CITY AND COUNTY OF SWANSEA

DEVELOPMENT MANAGEMENT AND CONTROL COMMITTEE

On: Thursday, 3 July 2014

| 3 | Swansea Bay Tidal Bay Lagoon - Local Impact Report and Written Representation. | 3 - 421 |

Figure 1. Map showing locations mentioned in the text, with bathymetry taken from the most recent Admiralty Charts (1161 and 1165), surveyed in large part 1980-1993 with minor recent corrections. Yellow lettering shows the main divisions of the Bay.

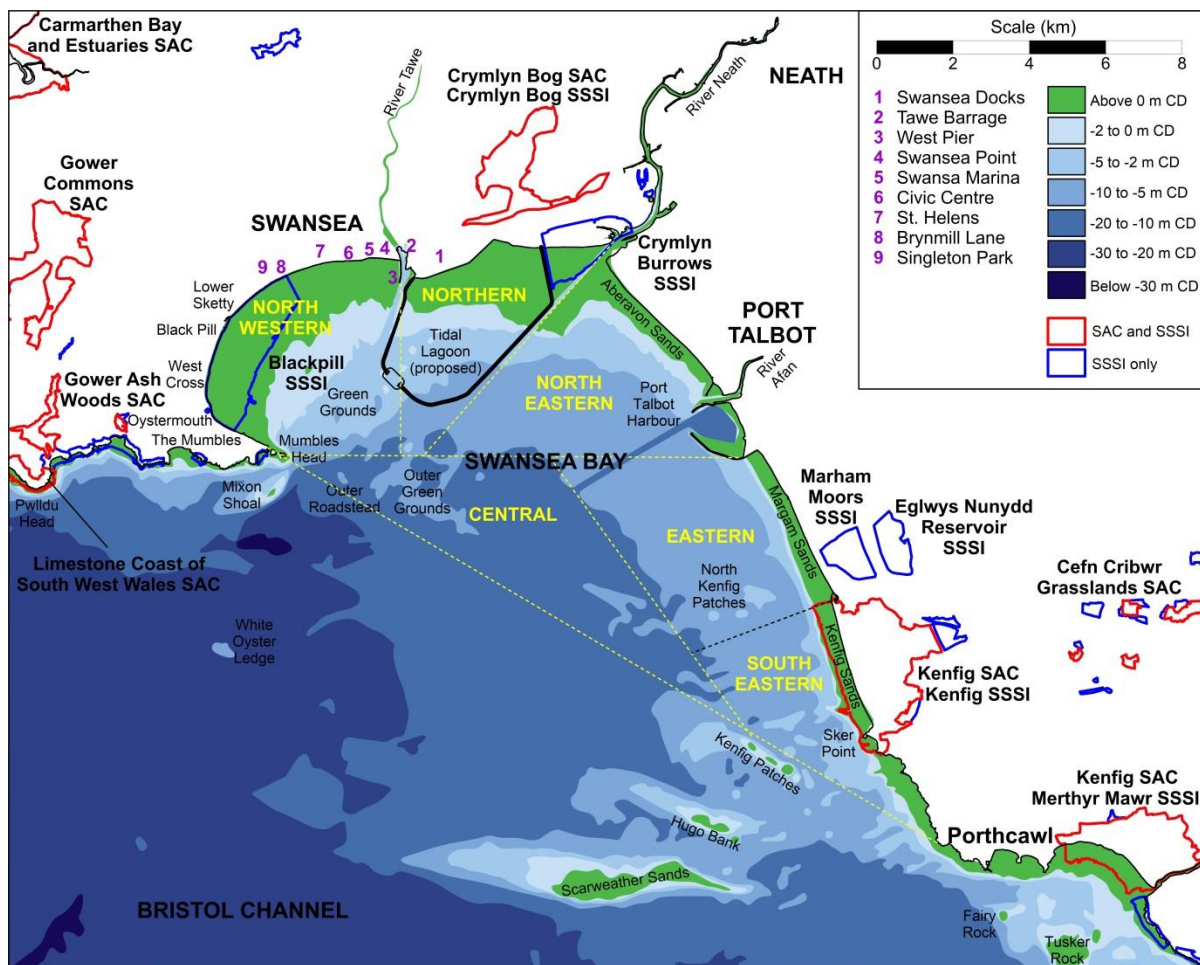
- 1.1 This report contains comments and advice to the City and County of Swansea (CCS) relating to the potential impacts of the proposed tidal lagoon development in northern Swansea Bay (Figure 1). Particular attention is given to the potential impacts of the Lagoon on coastal processes, sediment transport and rates of sediment accretion and erosion along the CCS frontage.

- The likely effect of the Lagoon development on the wind-blown sand problem which currently affects the promenade and coastal road between the Civic Centre and Bryn Mill Lane (Figure 1).

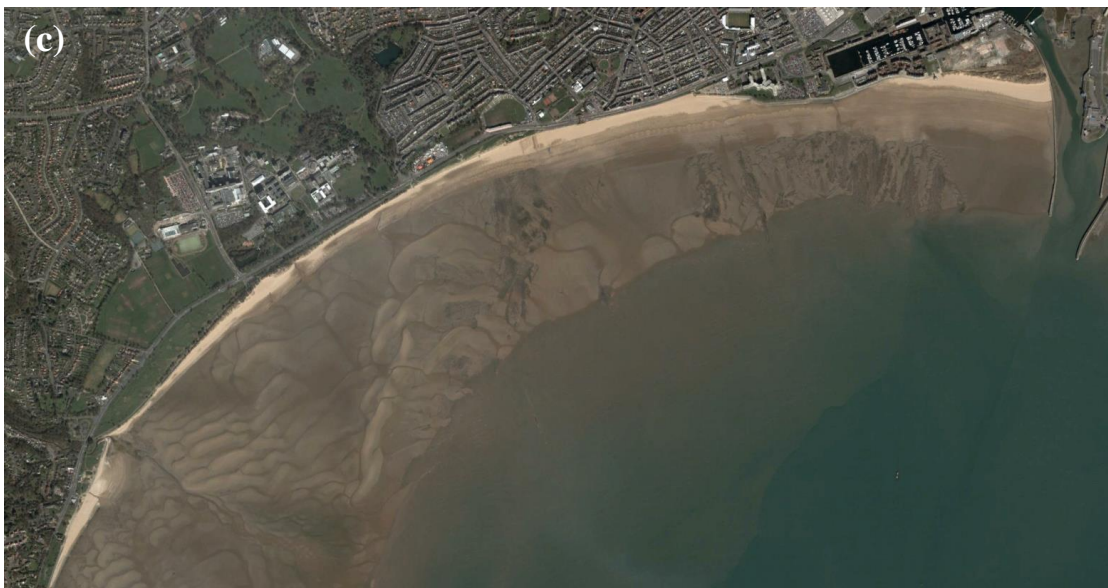
complex pattern of sand-waves which experiences significant change on annual to decadal timescales (Figure 2). No analysis of the importance of these features in onshore - offshore alongshore sand transport has been undertaken as part of the ES. No attempt has been made to construct a sediment budget for northwestern Swansea Bay, or to document net gains or losses of sediment using historical beach profile data or aerial photogrammetry. However, it is clear from a qualitative comparison of the aerial photographs and beach survey data that there have been periods when there has been a more or less continuous cover of mainly sandy sediment across the north-western part of the Bay, and others when the sand has been concentrated into discrete sand wave features separated by exposures of early to mid Holocene-age muds and peat. The width and elevation of the upper sandy beach between Black Pill and the Civic Centre has also varied in response to variations in wind and wave conditions. The period between 2000 and 2013 was one of relatively few storms and during this period there was a net movement of sand from the shallow sub-tidal areas and mid intertidal zone towards the higher intertidal zone. By 2005/6 a very large quantity of sand had accumulated on the upper beaches, giving rise to significant problems of windblown sand incursion onto the promenade and Oystermouth Road (see below). The problem has continued until the winter of 2013/14, when a series of severe storms caused significant upper beach and frontal dune erosion and transfer of sand back to the mid / lower intertidal zone (Pye & Blott, 2012, 2014a,b). However, since the 1970s there has been significant net accretion of littoral sand in northwestern Swansea Bay between the south side of Black Pill and West Pier with the exception of the Civic Centre frontage which lies seaward of the general shoreline alignment (see comparison of beach profiles in Figure 6).
